**ADDENDUM # 1**

<b>Project</b>	TA Blakelock High School Renovations	<b>Project No.</b>	2215-C
<b>Location</b>	1160 Rebecca Street, Oakville, ON	<b>Date of Issue</b>	2025 04 24
<b>Owner</b>	Halton District School Board	<b>File</b>	2215/7.1.3

This Addendum forms part of the Contract Documents and amends the original Drawings and Specifications, dated 2025 04 17, and all preceding Addenda, as noted below.

4 PARTIAL LEVEL 1 ELEVATOR 01 - NEW HVAC PLAN  
M300 1:50

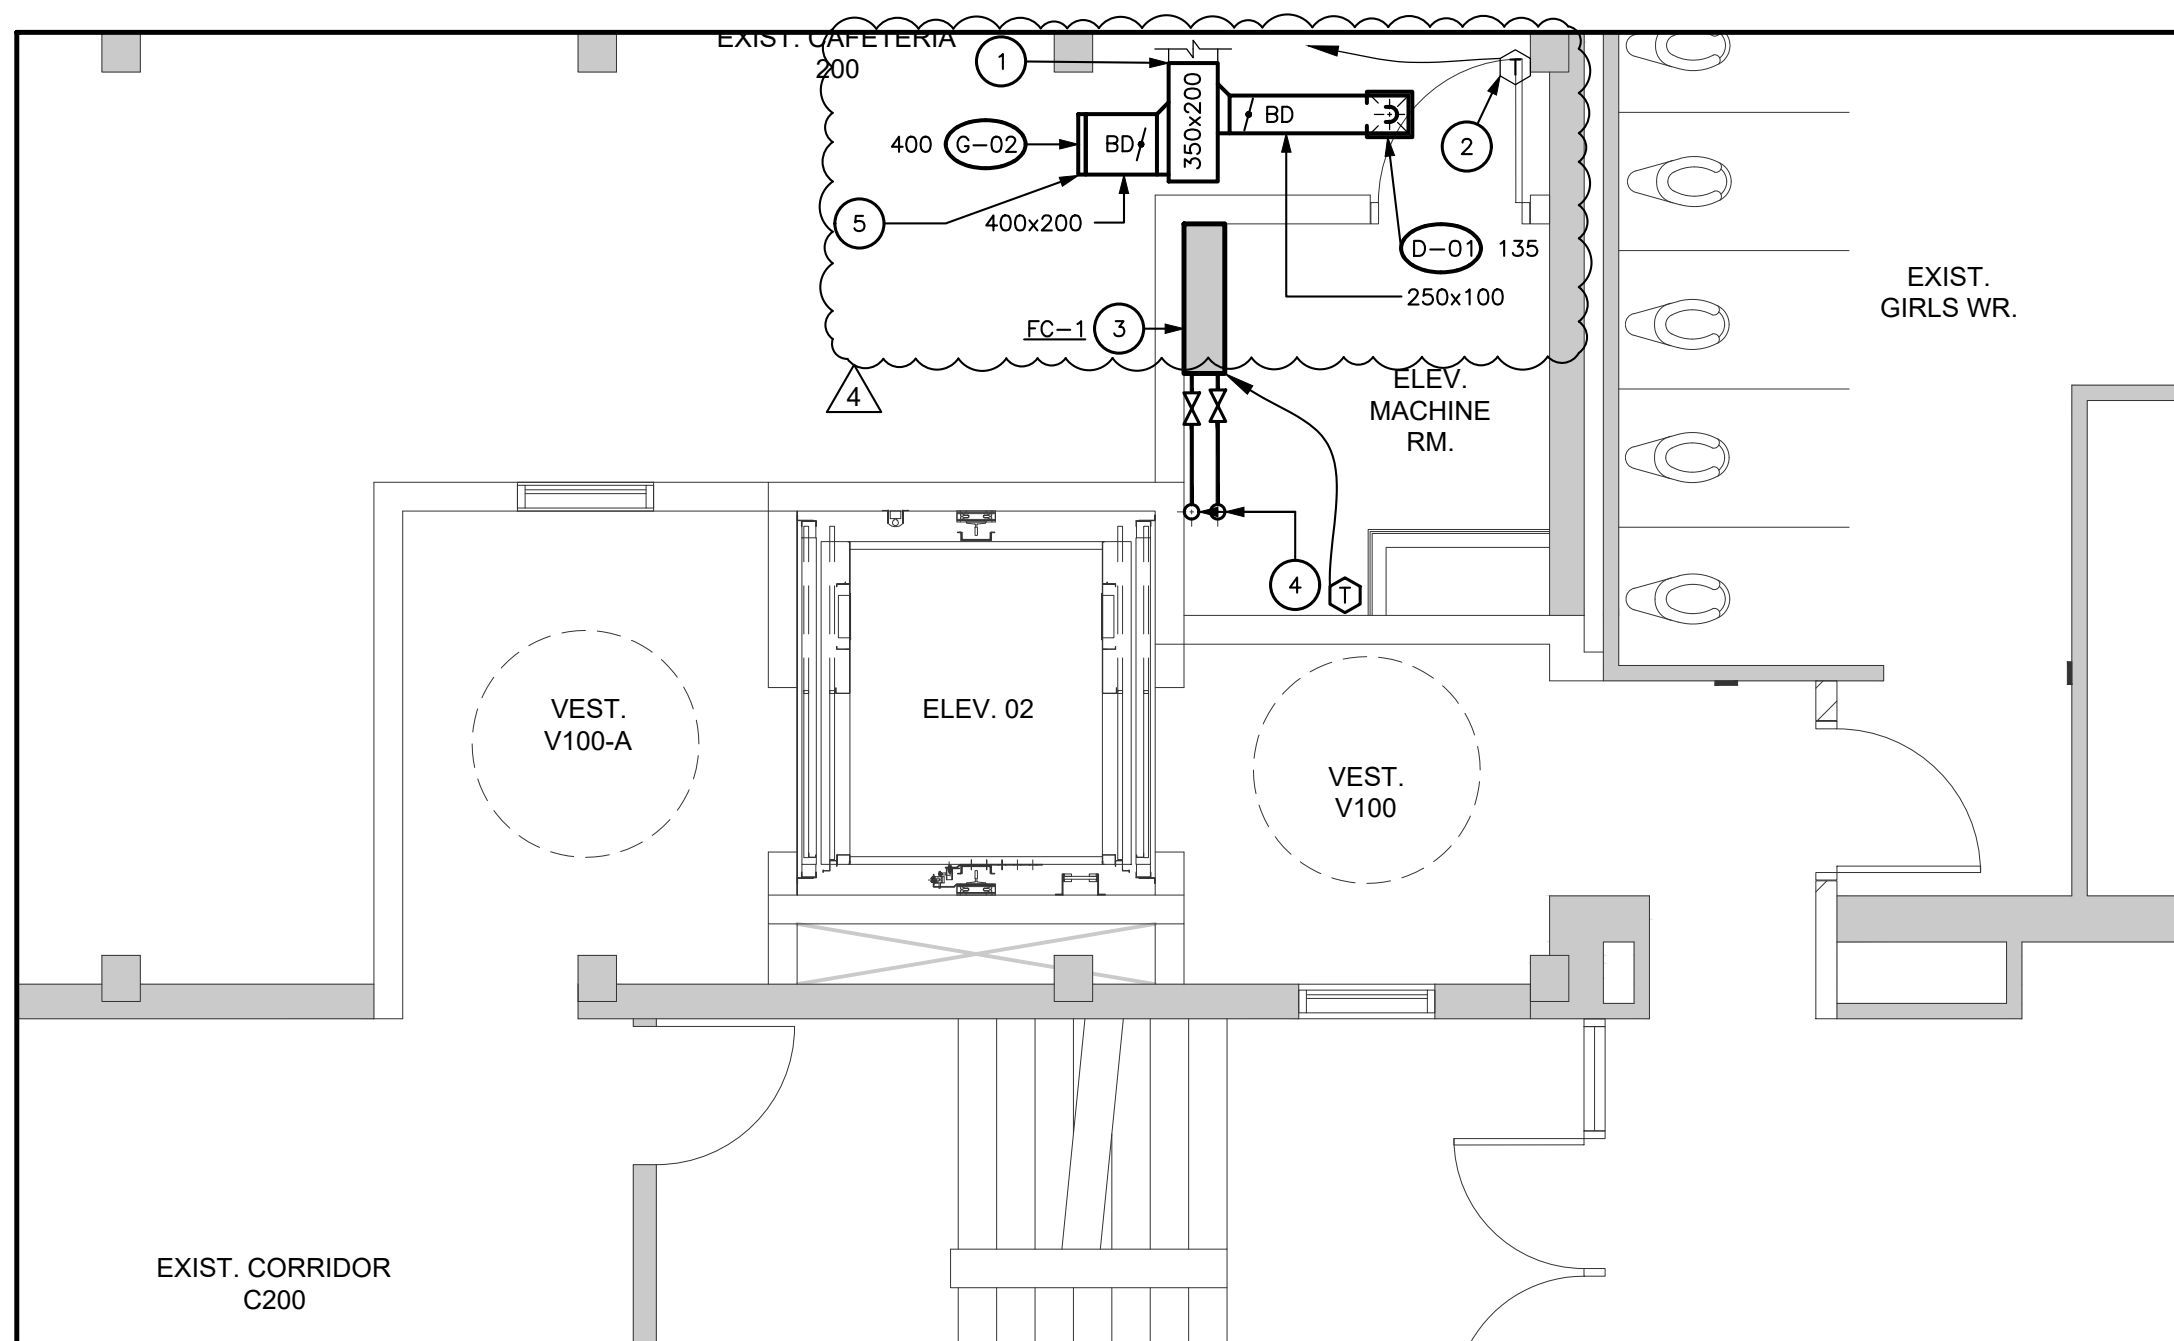
- .2 **ADD** Refrigerant piping to serve new fan coil.
  - .3 **Refer to Partial Level 1 Elevator 01 – New HVAC Plan:**
    - .1 **ADD** Refrigerant piping dropping from roof level down to floor below within furred

- .4 **Refer to Partial Level 1 Elevator 02 – New HVAC Plan:**
    - .1 **REVISE** Ductwork layout as indicated on included drawings.
    - .2 out wall.
